Revisions			
P01	14.07.16	ADDITIONAL PLANNING INFORMATION	KI PY
P02	09.03.17	PLANNING AMENDMENT SUBMISSION	KI LP

**PLANNING AMENDMENTS**

**TWICKENHAM STADIUM  
EAST STAND EXTENSION**

**LEVEL 6 PLAN - SOUTH**

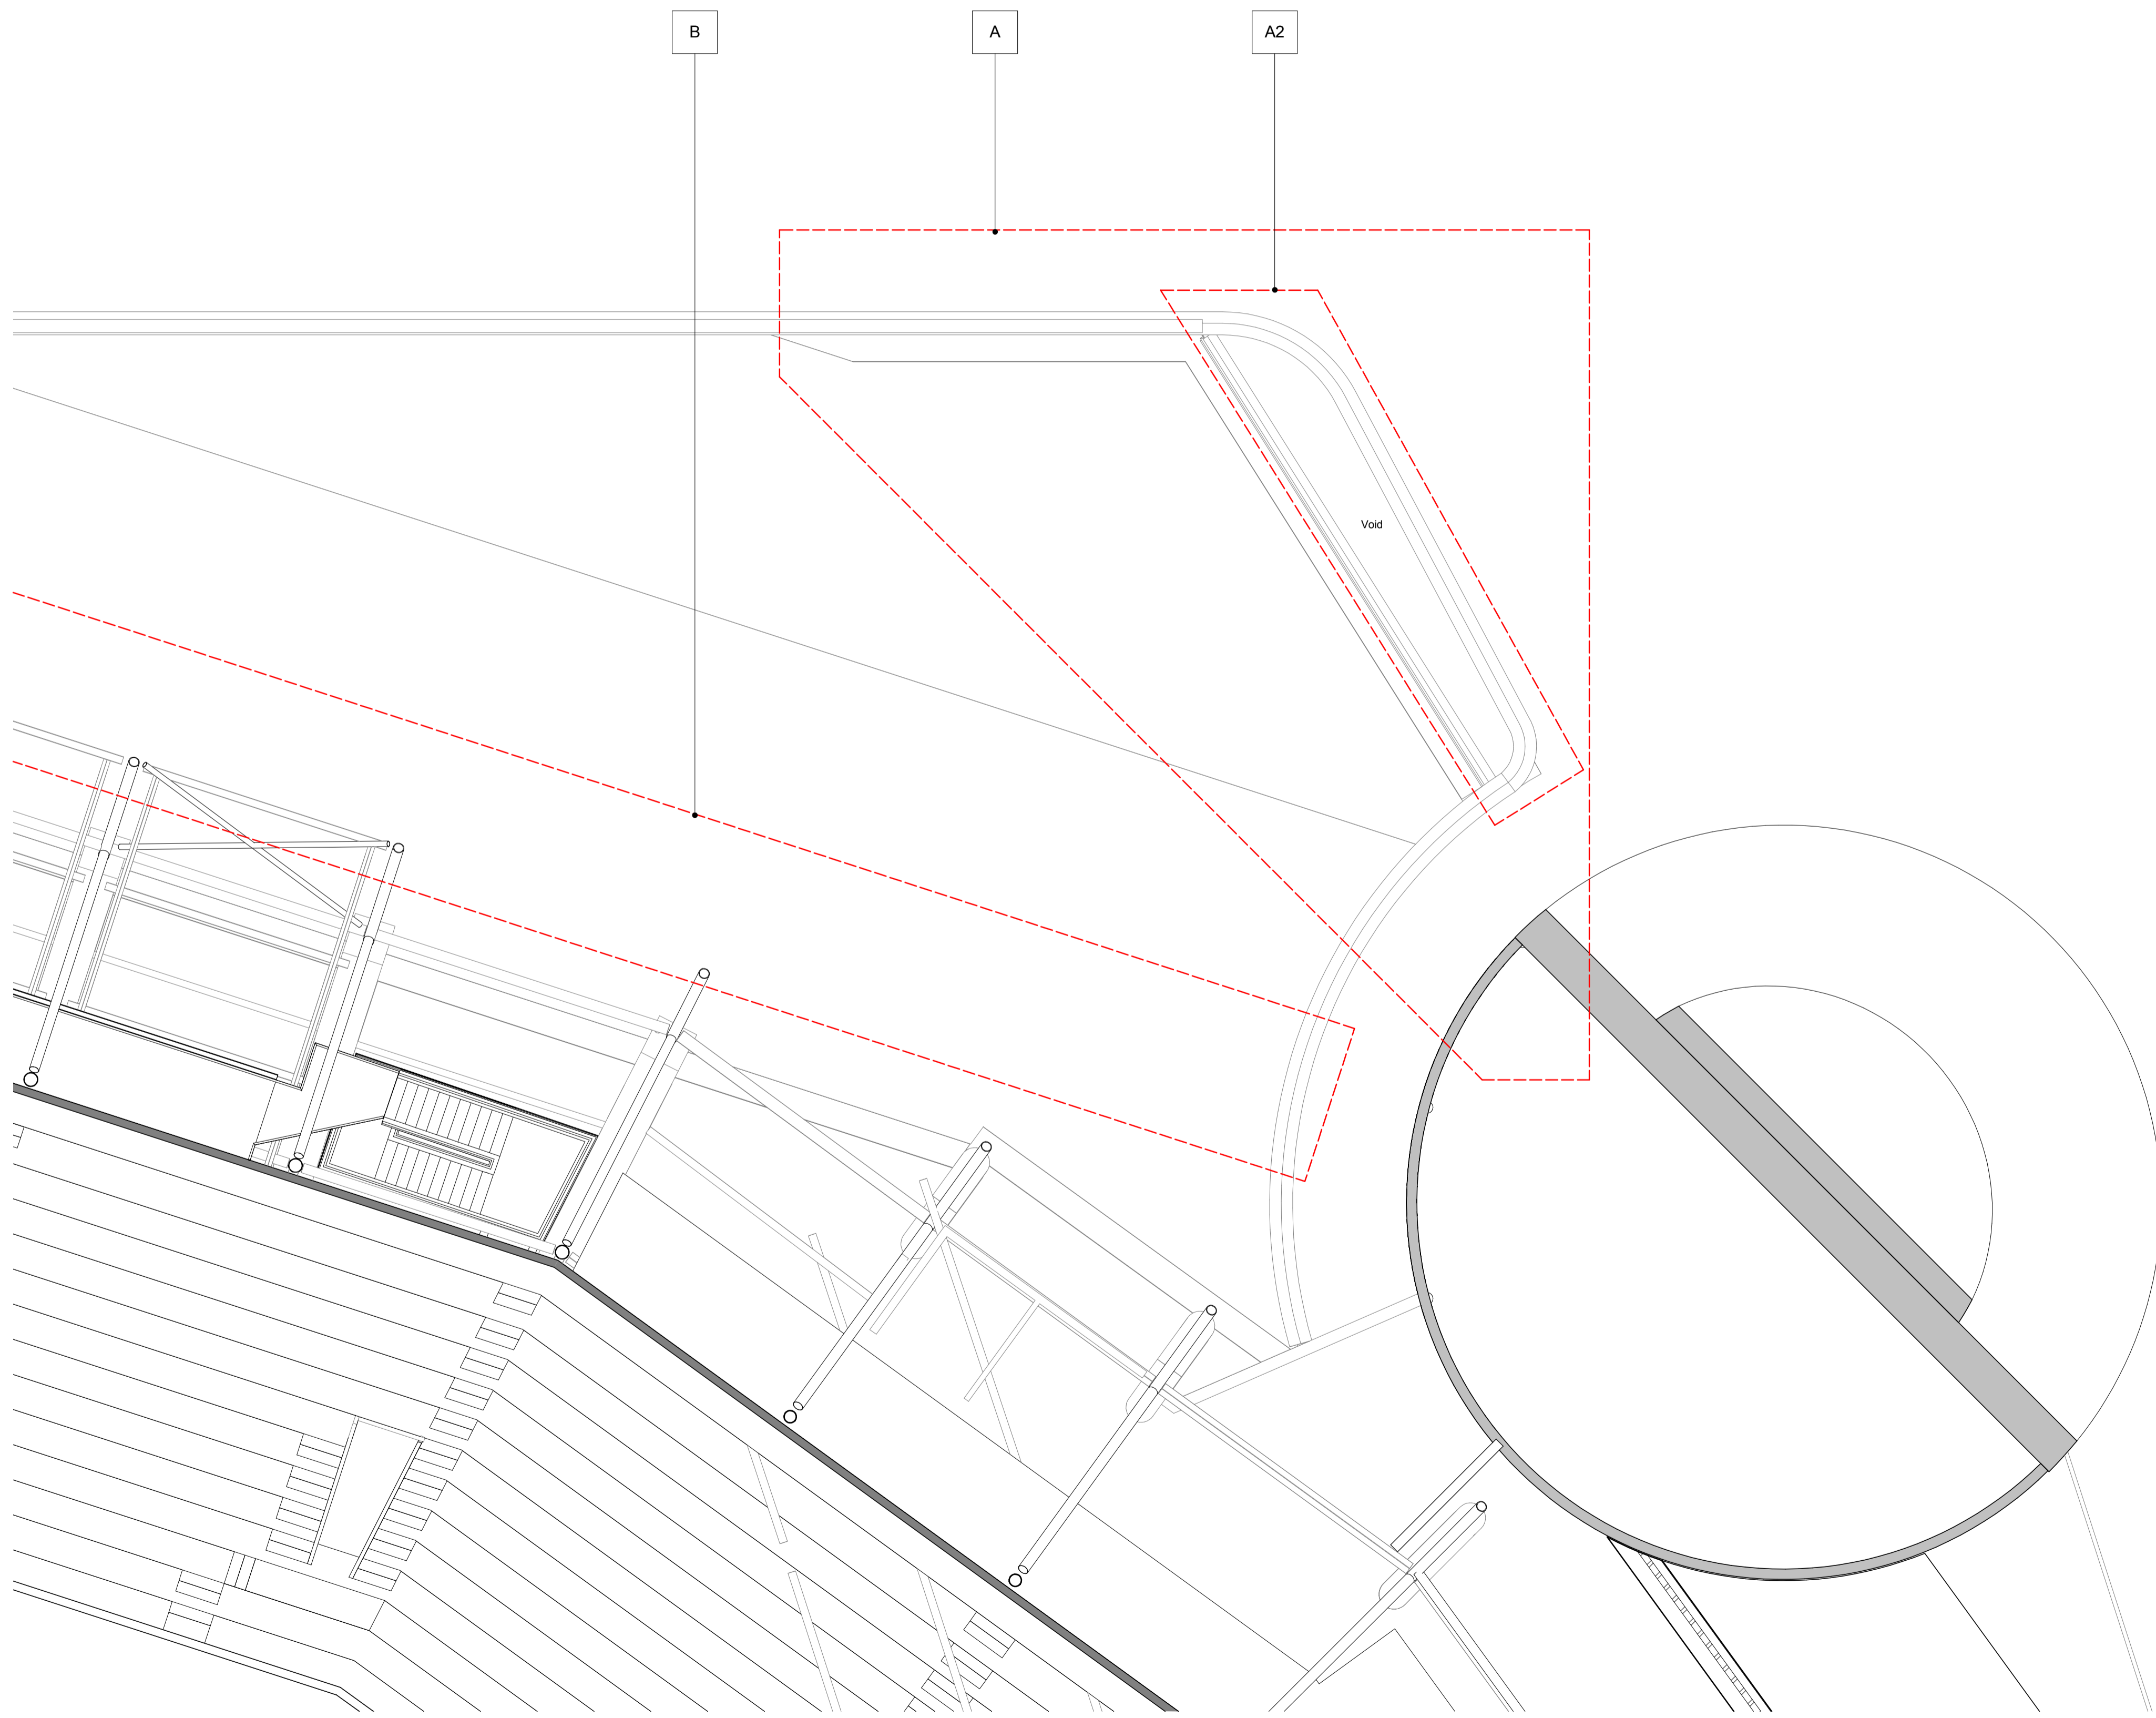
- A GENERAL AMENDMENTS TO THE SOUTH END.
- A1 INCREASED SHINGLES CLADDING AREA AND CURTAIN WALL REDUCED ACCORDINGLY.
- A2 REDUCED MASSING AND REVISED INTERFACE WITH THE SOUTH STAND.

- B PPC LOUVRES LOCATED TO THE BOWL SIDE HAVE BEEN OMITTED.
- C CURTAIN WALL SETTING OUT REVISED GENERALLY. SILICONE JOINTS TO TRANSOMS AND MULLION REPLACED WITH CAPPED SYSTEM. LEVEL 04 PPC LOUVRES SETTING OUT & HEIGHT REVISED. MONORAIL FOR ABSEILING REMOVED.

- D GENERAL AMENDMENTS TO THE CENTRAL ELEVATION CANOPY AT LEVEL 5A REVISED GENERALLY AND STANDING SEAM REPLACED WITH SINGLE PLY MEMBRANE. SUPPORT COLUMNS TO ROOF CANOPY REVISED. SQUARE FASCIA TO ROOF EDGE.

- D1 LEVEL 5A GLAZED SCREEN EXTENDED IN HEIGHT AND PPC LOUVRES INCLUDED AT LOW LEVEL.
- D2 INCREASED SHINGLES CLADDING AREA AND CURTAIN WALL AREA REDUCED ACCORDINGLY. FOUR VERTICAL FINIS REMOVED.

- D3 PORCELAIN PANELS WITH SLOTTED HOLES FOR VENTILATION REPLACED WITH PPC LOUVRES. EXPRESSED HORIZONTAL PATTERN TO PORCELAIN PANELS OMITTED.
- E GENERAL AMENDMENTS TO THE NORTH END

- E1 PORCELAIN CLADDING REPLACED WITH PPC ALUMINIUM CLADDING.
- E2 GREEN WALL TO THE NORTH END EXTENDED AND PPC LOUVRES REMOVED.
- E3 INCREASED SHINGLES CLADDING AREA AND CURTAIN WALL REDUCED ACCORDINGLY.

- F FENCELINE, GATE AND PERIMETER COLUMNS SETTING OUT REVISED.
- F1 CANOPY TO TURNSTILES REVISED.
- G PORCELAIN PATTERN CHANGED FROM HORIZONTAL TO VERTICAL.

- H PORCELAIN PANELS TO THE SOFFIT OF THE ARCH REPLACED WITH PPC ALUMINIUM PANELS. PORCELAIN PANELS SETTING OUT REVISED.
- K ROOF TO LEVEL 5A (NORTH END) EXTENDED.

- L GLAZED SPANDREL PANELS REPLACED WITH METAL SPANDREL PANEL. PORCELAIN PANELS REPLACED WITH PPC ALUMINIUM CLADDING.
- L1 PPC LOUVRES INCLUDED FOR MECHANICAL VENTILATION.
